**GE Hitachi Nuclear Energy
Global Laser Enrichment, LLC**

Letter number MFN-09-690

**SUBJECT: GE-HITACHI GLOBAL LASER ENRICHMENT RESPONSE TO REQUEST FOR
ADDITIONAL INFORMATION RELATED TO NRC REVIEW OF GLE
ENVIRONMENTAL REPORT**

Enclosure 1 GLE Response to Environmental RAIs

Figure 4.5(E): Age and Condition of Biotic Communities Dominated by Pine

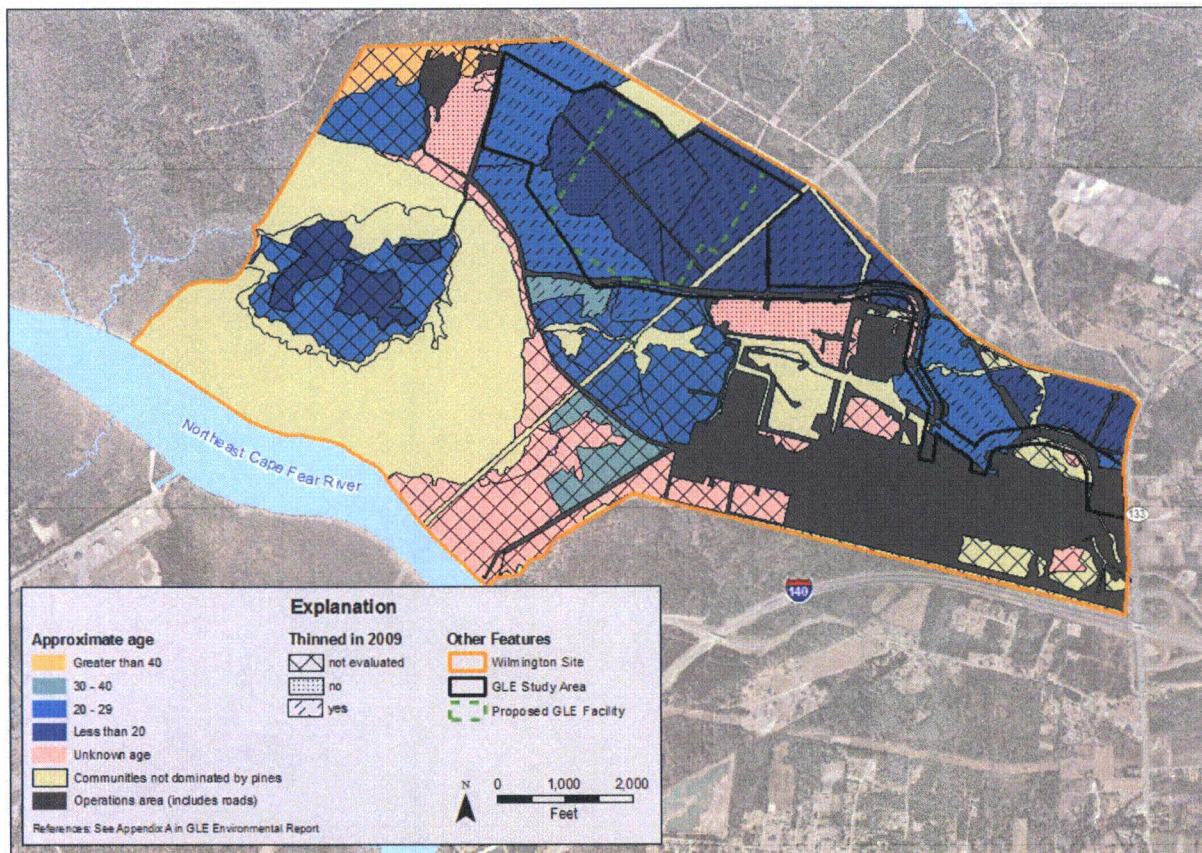
E. Provide the most recent dates and areas where logging has occurred in the area proposed for the GLE facility. Also, provide whatever similar summary data is available for logging on the Wilmington site since 1980 (approximately). This information is needed to support conclusions about the suitability of the site for red-cockaded woodpecker habitat.

In February 2009, GE-Wilmington implemented a Forest Management Plan (see Enclosure 3 for the Plan Summary with proprietary information redacted) to thin all planted and natural stands that were biologically ready and economically feasible. The plantations were treated via a third-row thinning to favor saw-timber production. Due to the very high initial stand densities, it was found that most of the natural stands required thinning to residual row spacing approximately the same as the plantations. The wider residual row spacing originally prescribed for the natural stands would not have accomplished the objectives of these thinning.

Figure 4.5(E) illustrates the age of the forest communities based on the 2009 GE Forest Management Plan; however, this scale is not at a fine enough resolution to identify areas that were planted versus naturally regenerated. The area within or adjacent to the GLE Study Area was observed in October 2009 to verify which areas had received thinning treatments. In addition to being thinned, some areas received additional reduction of sub-canopy vegetation within the rows.

Figure 4.5(F). Planned Projects on the Wilmington Site.

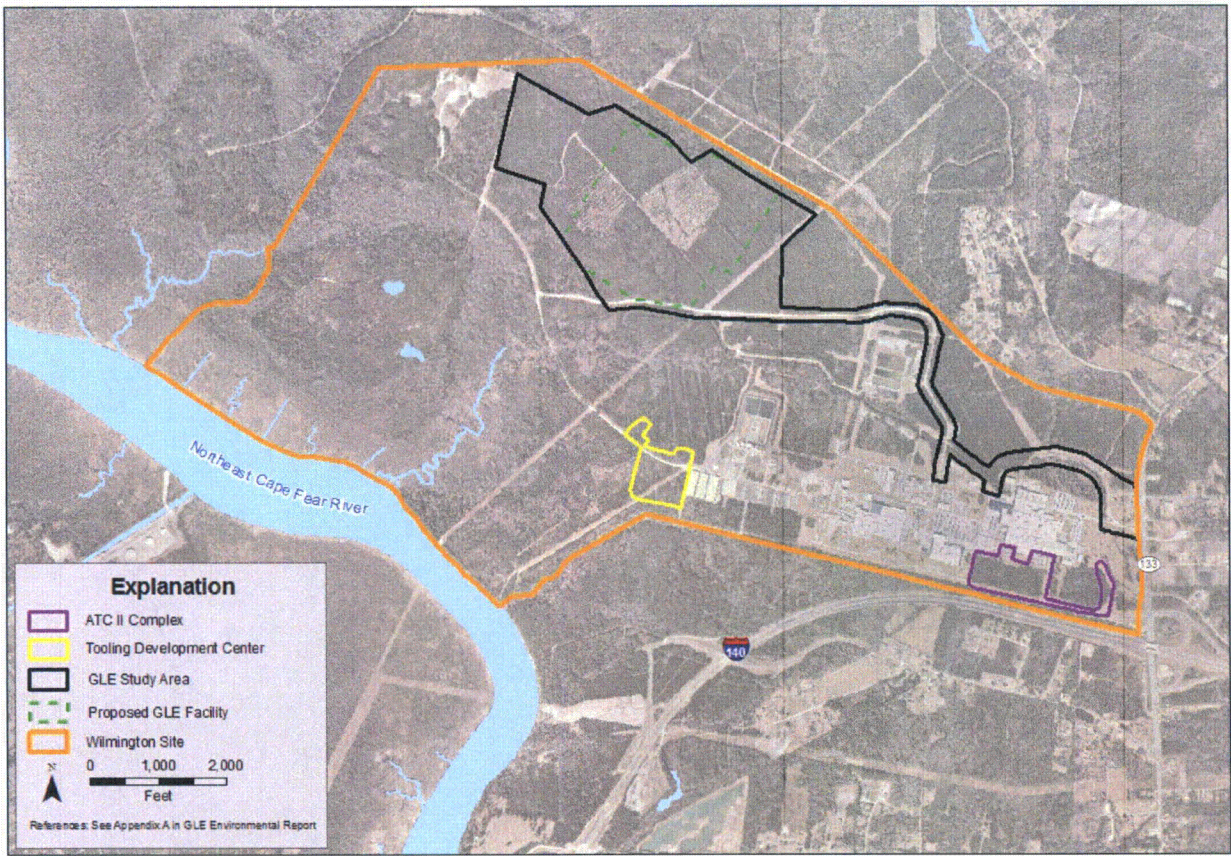
- F. Provide a figure similar to ER Figure 1-2 that shows the “30-acre” area outlines for the proposed ATC II complex and the Tooling and Development Center. This information is needed for the cumulative impacts analysis.

Figure 4.5(F) illustrates the location of the proposed ATC II Complex and the Tooling Development Center on the Wilmington Site. The ATC II complex in the southeastern portion of the Eastern Site Sector near the South Gate has impacted approximately 20.66 acres (8.36 ha) consisting of 11.30 ac (4.57 ha) of Pine Forest and less than 0.01 acres (0.01 ha) Pine-Hardwood Forest.

The Tooling and Development Center would impact approximately 16.31 acres (6.60 ha), consisting of 0.28 ac (0.13 ha) of Pine Forest, 7.27 ac (2.94 ha) of Pine-Hardwood Forest, and 6.45 ac (2.61 ha) of Pine Plantation habitat in the western portion of the Eastern Site Sector. The cumulative effect from both of these projects would be the loss of approximately 24.3 acres (9.8 ha) of habitat in conjunction with the loss of approximately 177 acres (72 ha) of habitat from the Proposed Action. Total loss of available habitat would be approximately 202 acres (82 ha), comprising 16% of the forest habitat currently on the Wilmington Site.
